**APPLICATION NUMBER:** RECON 24/0467

**PROPOSAL:** RESERVED MATTERS APPLICATION FOR SPORTS PITCHES, CHANGING FACILITIES AND ALLOTMENTS, ASSOCIATED INFRASTRUCTURE AND LANDSCAPING PURSUANT TO OUTLINE PLANNING PERMISSION 16/0864

**SITE:** Llanwern Village Development Site Phase 1 Cot Hill Llanwern Newport NP18 2DP

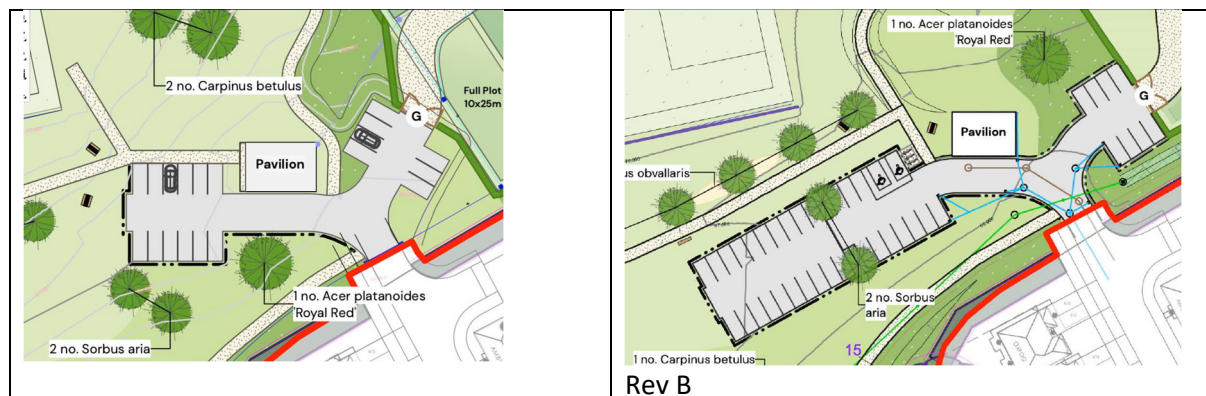
3. The key landscape plan is 'Sports park & northern public open space' soft landscape plan by Pegasus, revised to rev B – see extract below. My previous comment on the lack of planting to soften or enclose the car parking, pavilion building, and site entrance has been responded to by adding 2 no trees. In my view this is inadequate and will not help to create a welcoming and human-scale landscape. In addition, the main car park has been extended significantly from the original but there is no additional planting to soften views for park users or for overlooking properties. A more detailed planting scheme by Pegasus is needed for what will be the central hub of the wider park.
